EPC STORMWATER REVIEW COMMENTS
IN ORANGE BOXES WITH BLACK TEXT

STORMWATER MANAGEMENT PLAN (SWMP)

FOR
FLYING HORSE NORTH FILING NO. 4
SE OF SANDBAGGER DR & OLD STAGECOACH RD
UNINCORPORATED EL PASO COUNTY, CO 80908

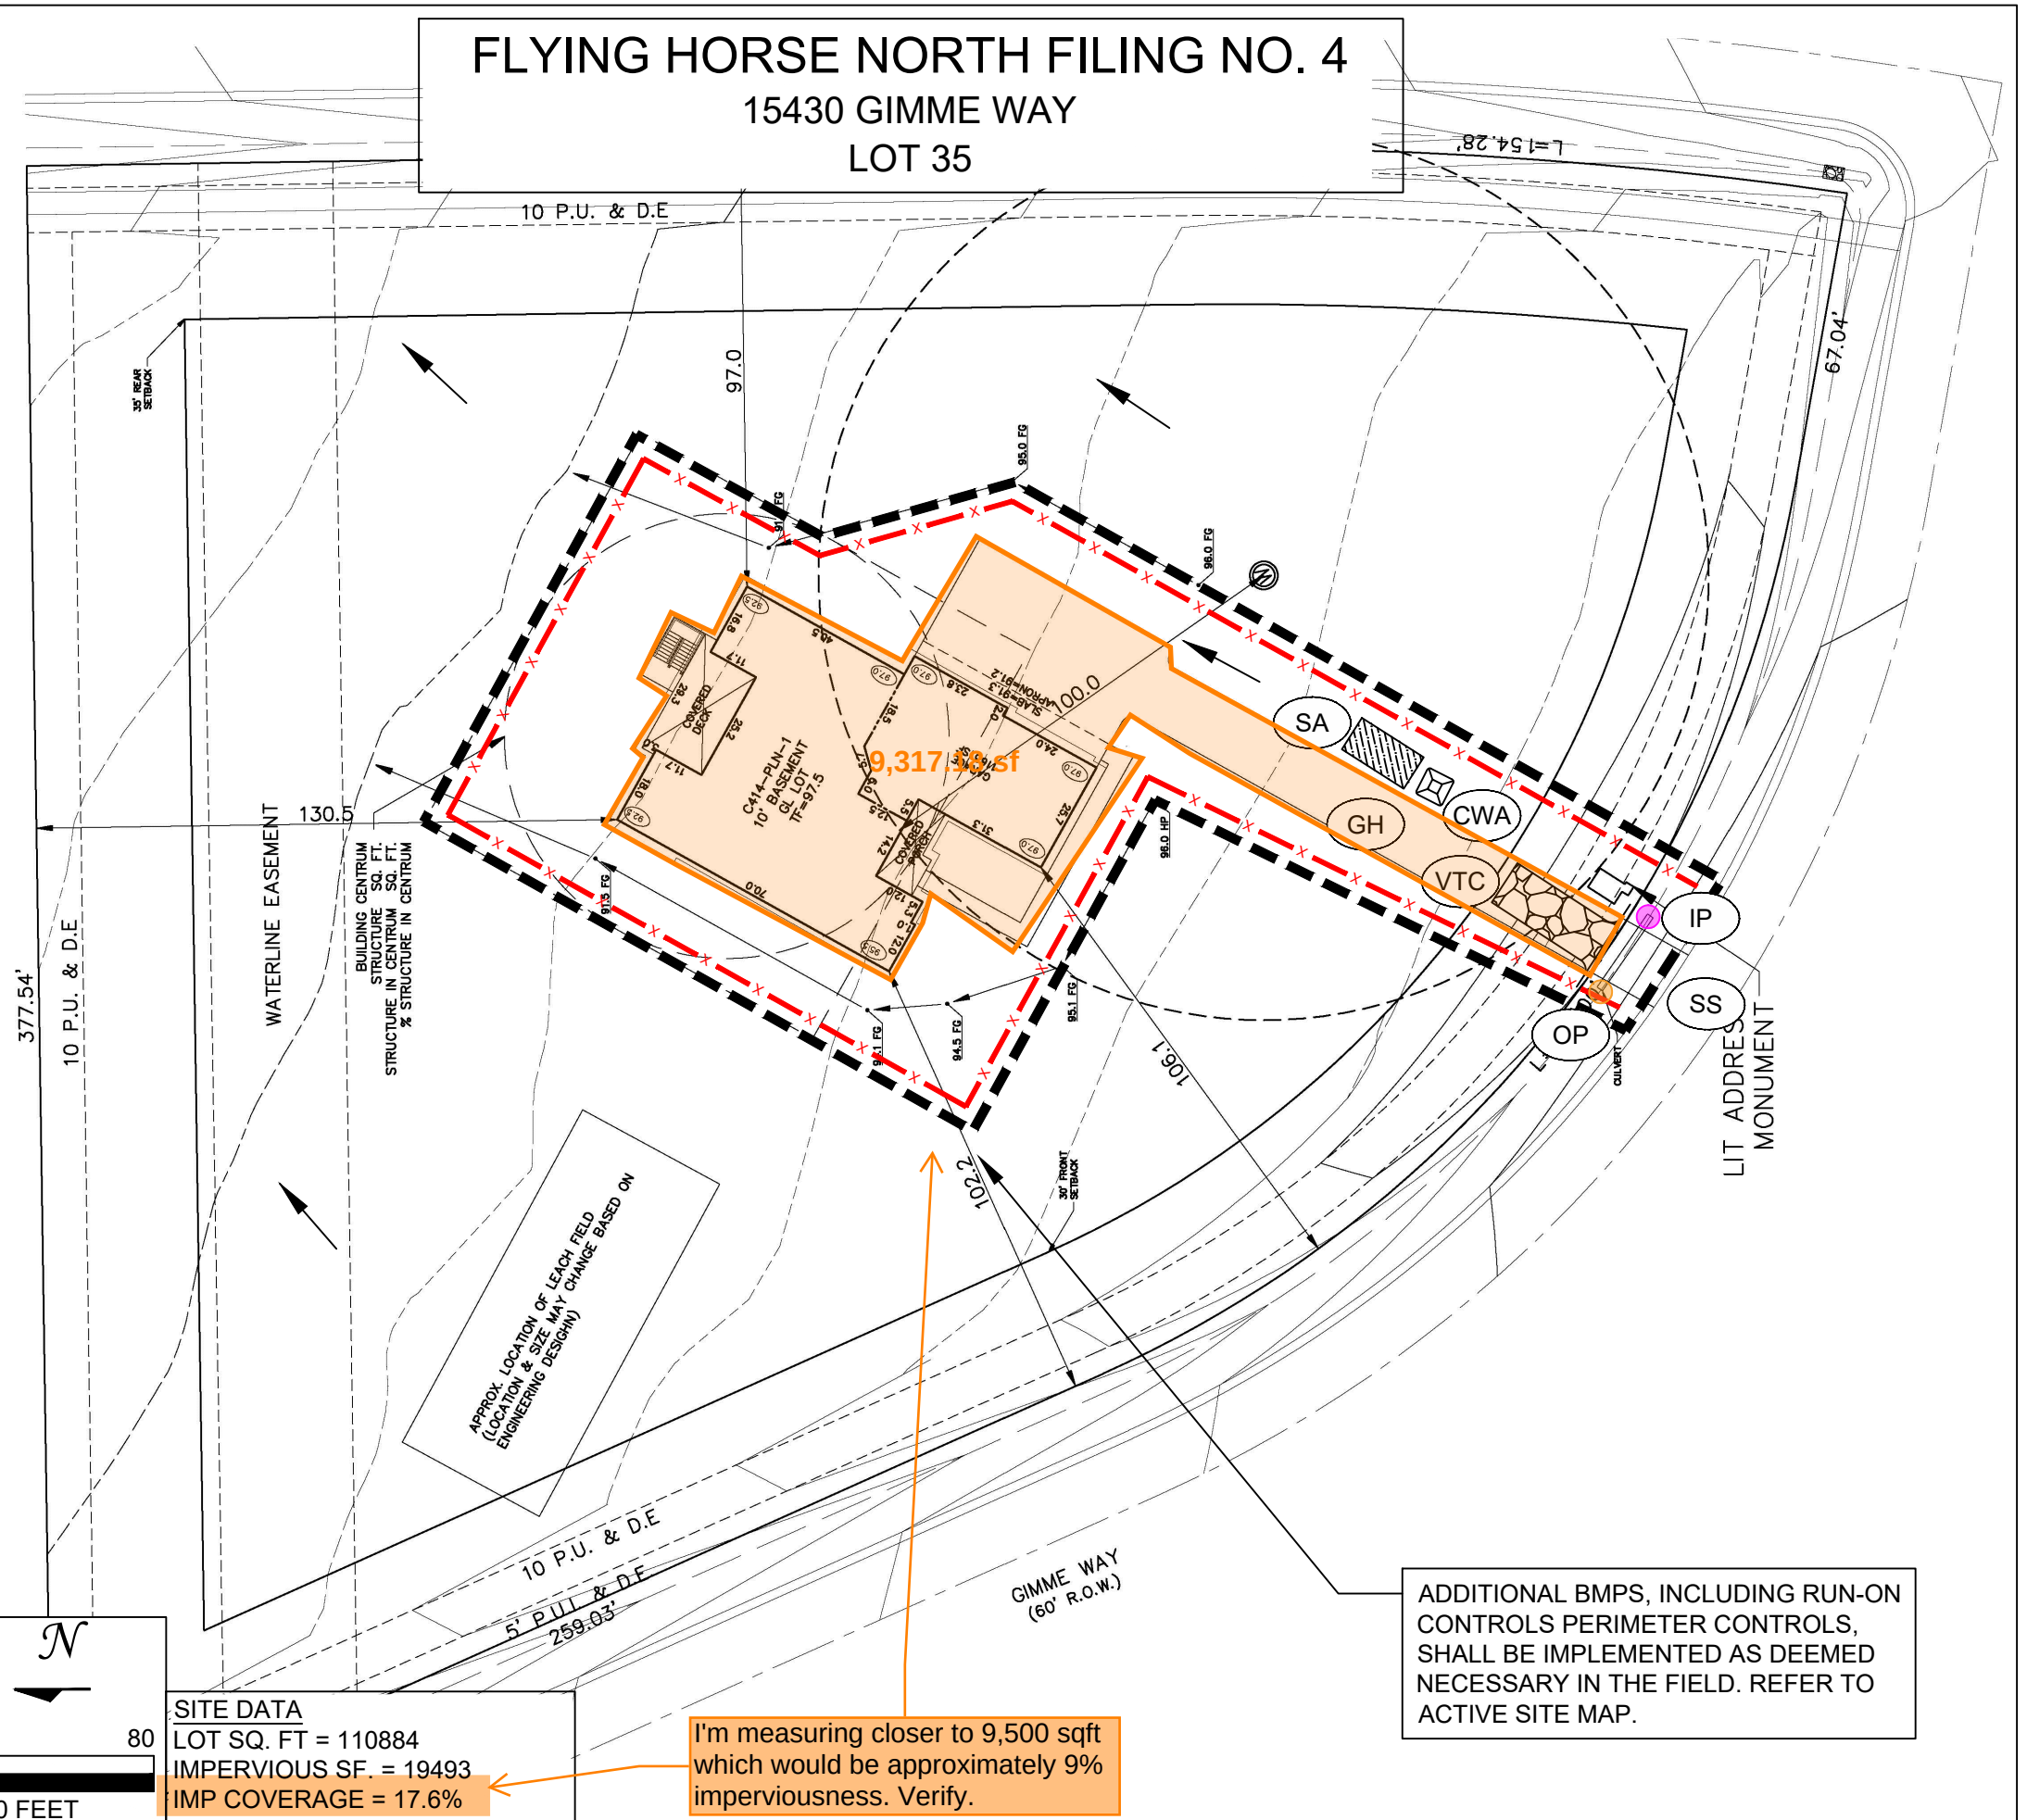
I'm measuring closer to 9,500 sqft which would be approximately 9% imperviousness. Verify.

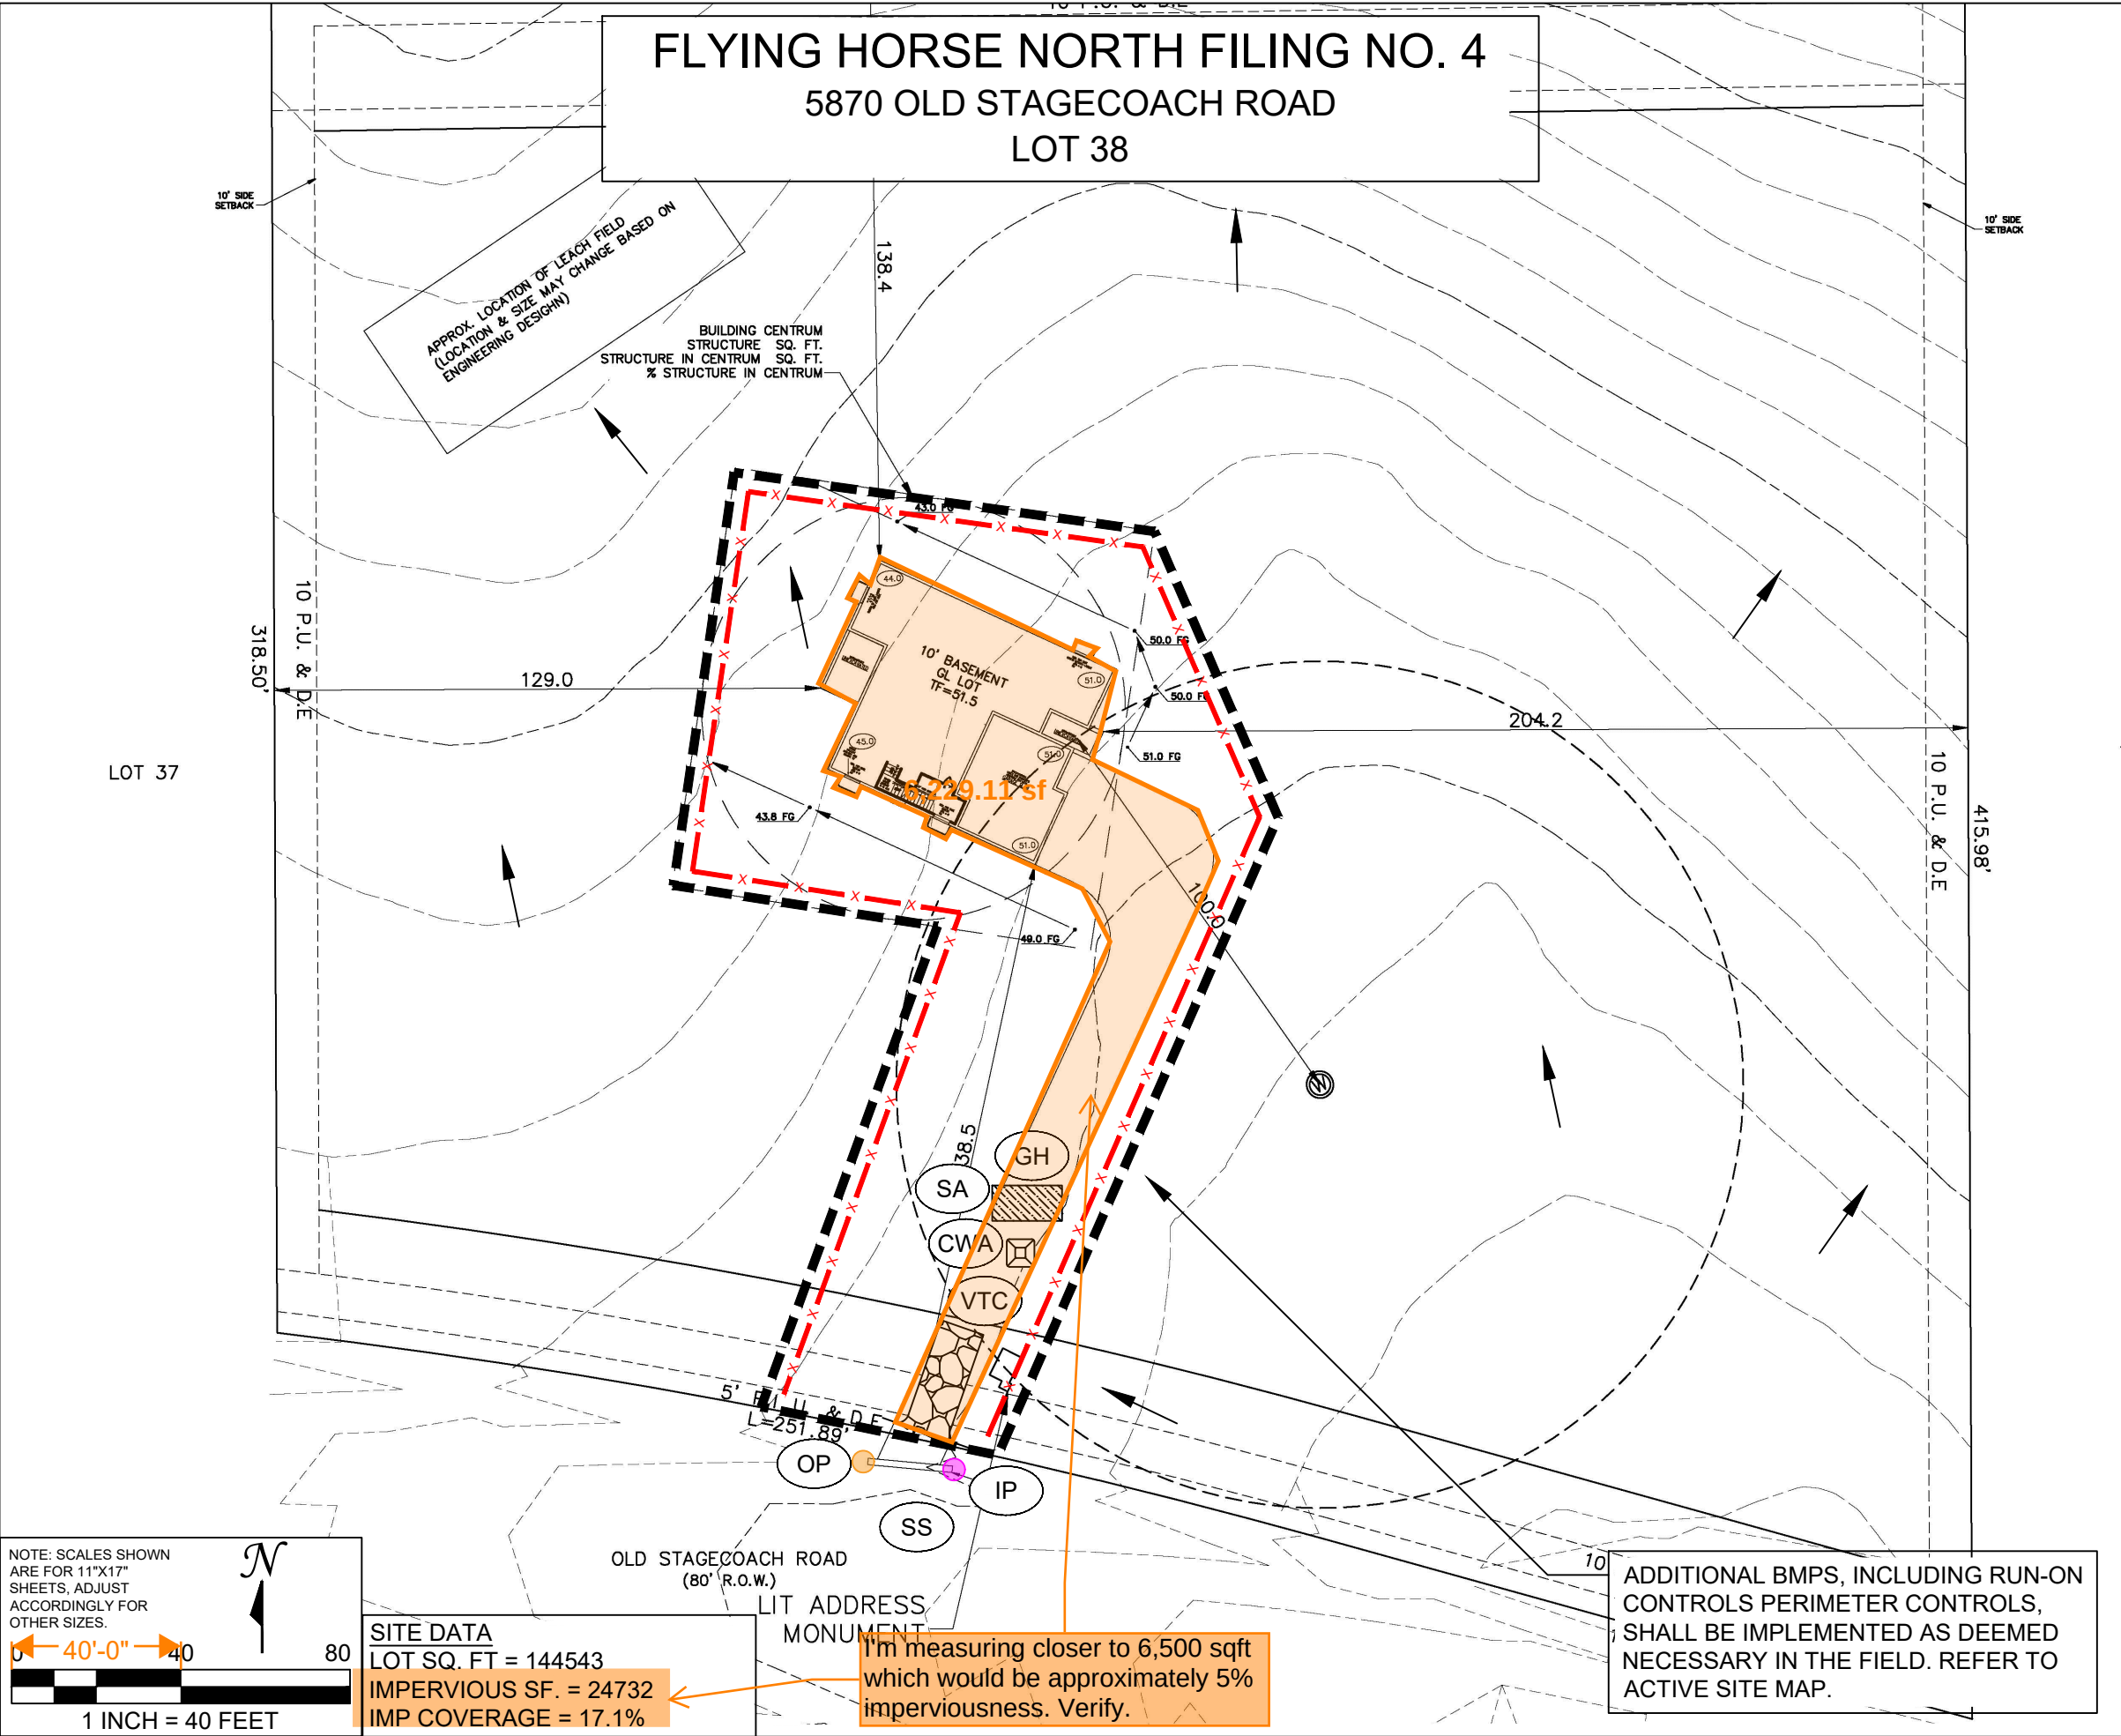
I'm measuring closer to 5,200 sqft which would be approximately 4% imperviousness. Verify.

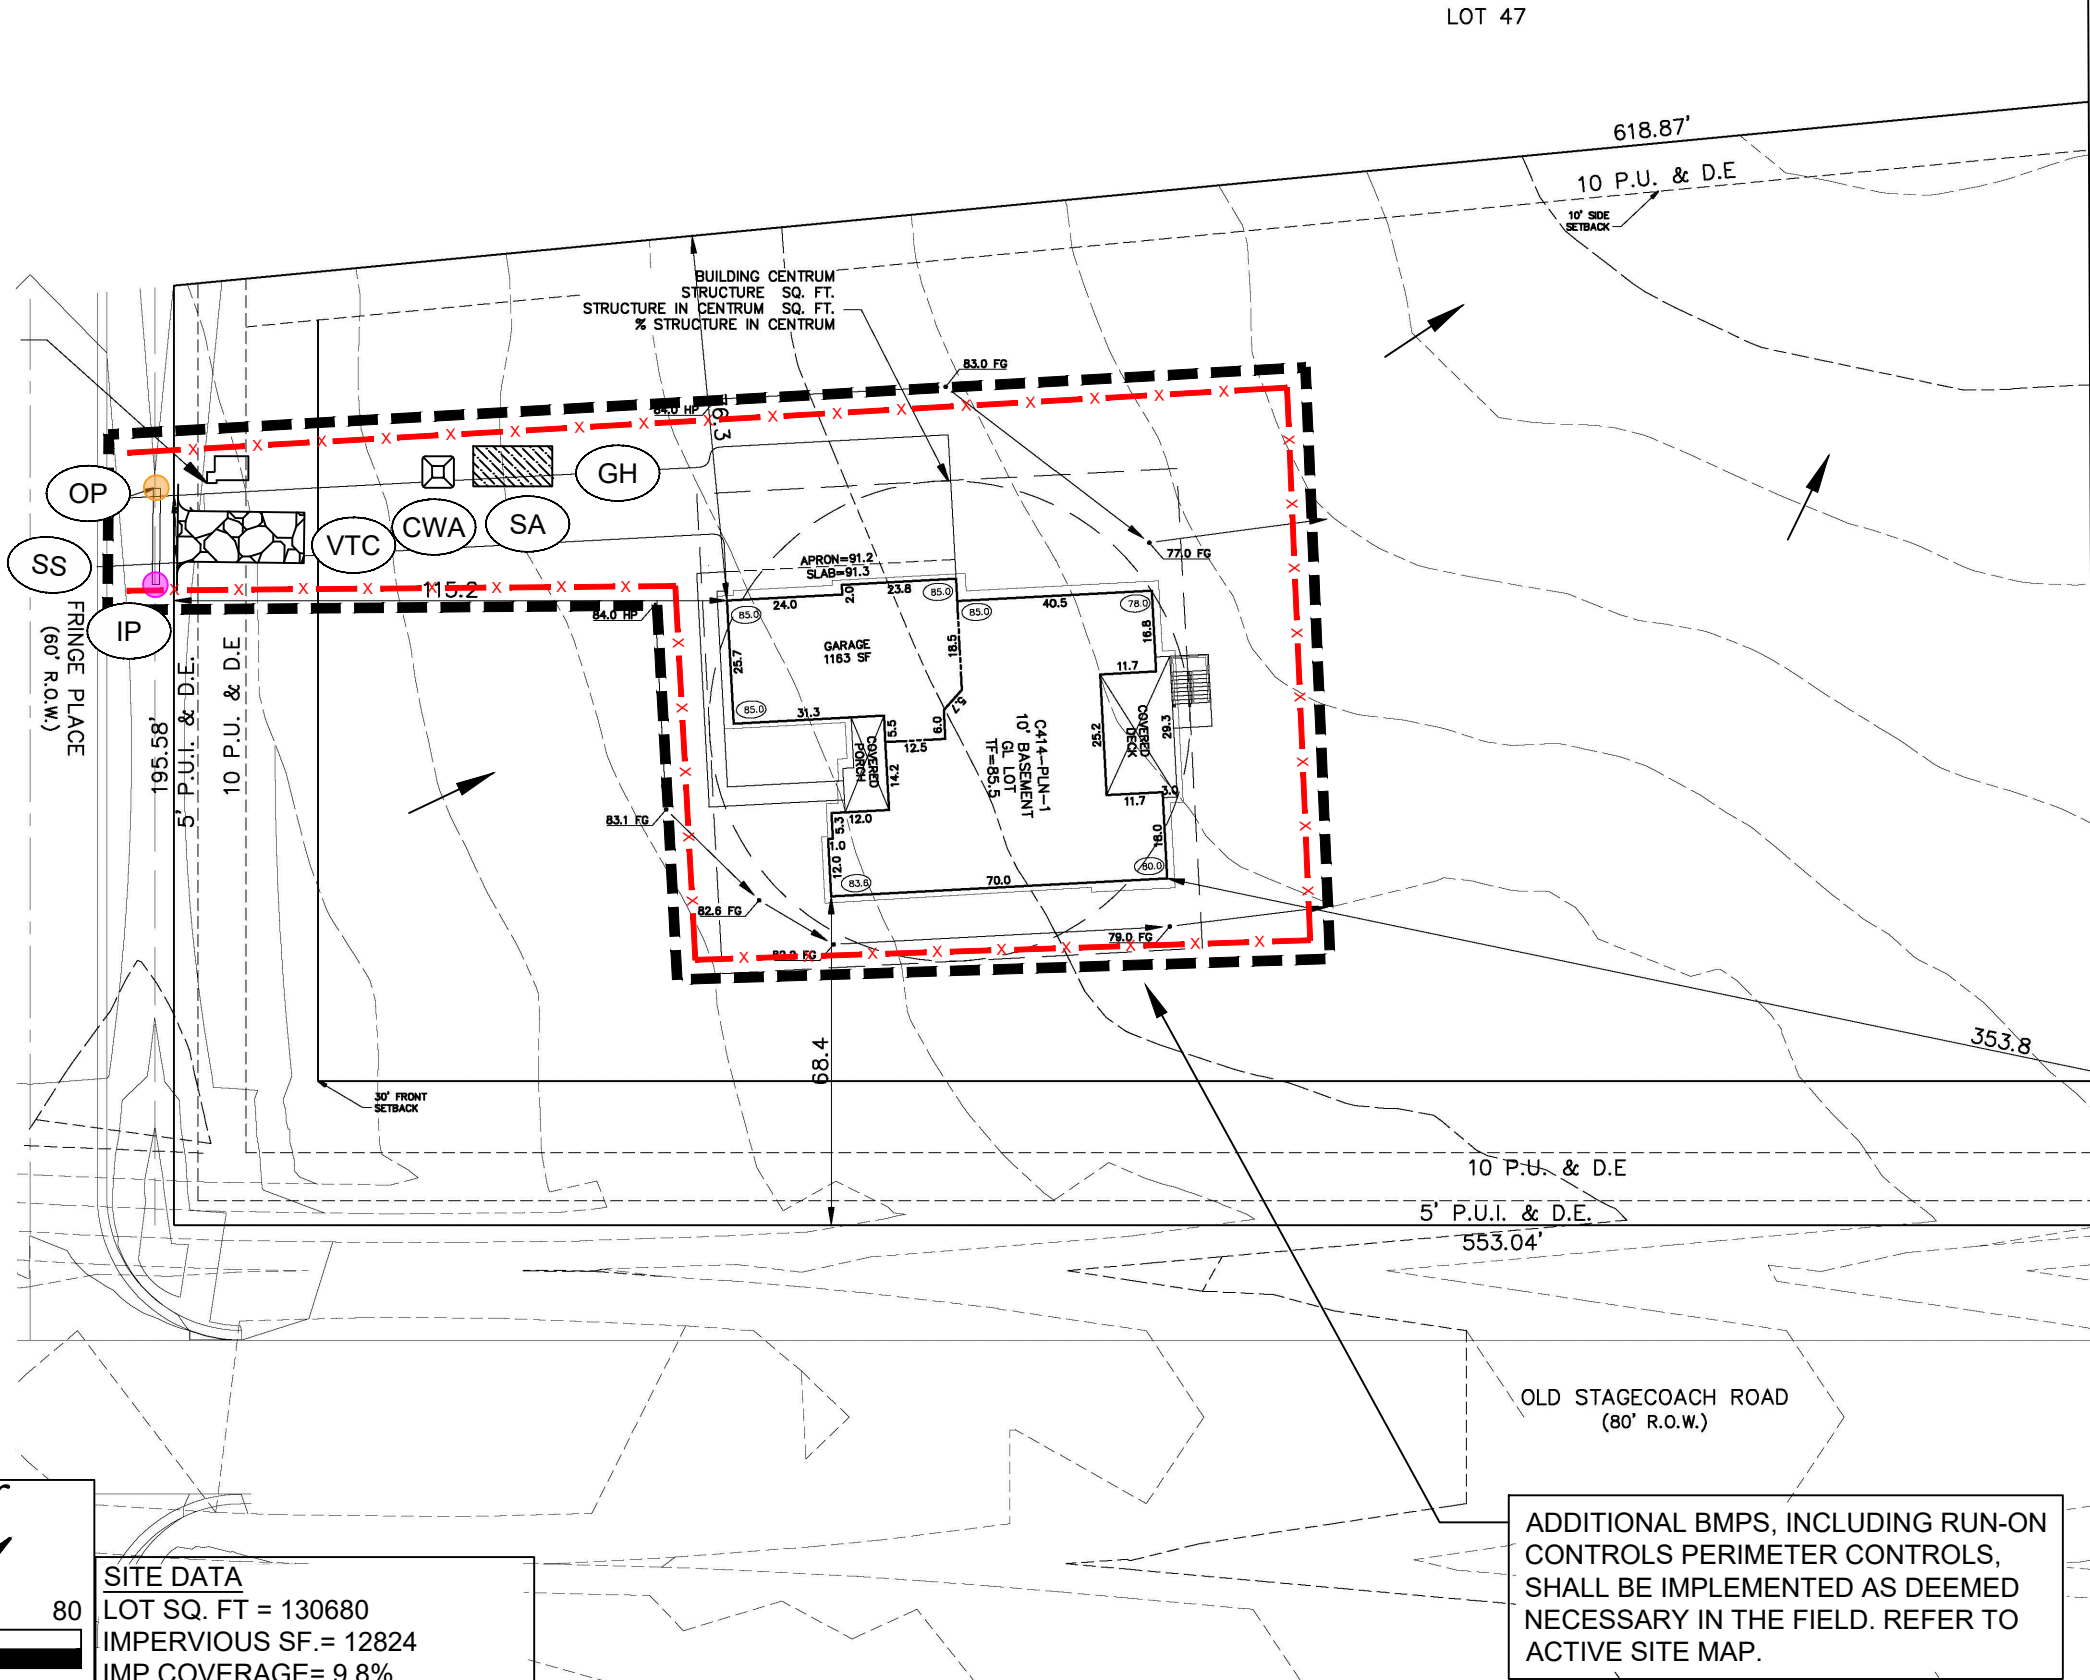
I'm measuring closer to 6,500 sqft which would be approximately 5% imperviousness. Verify.
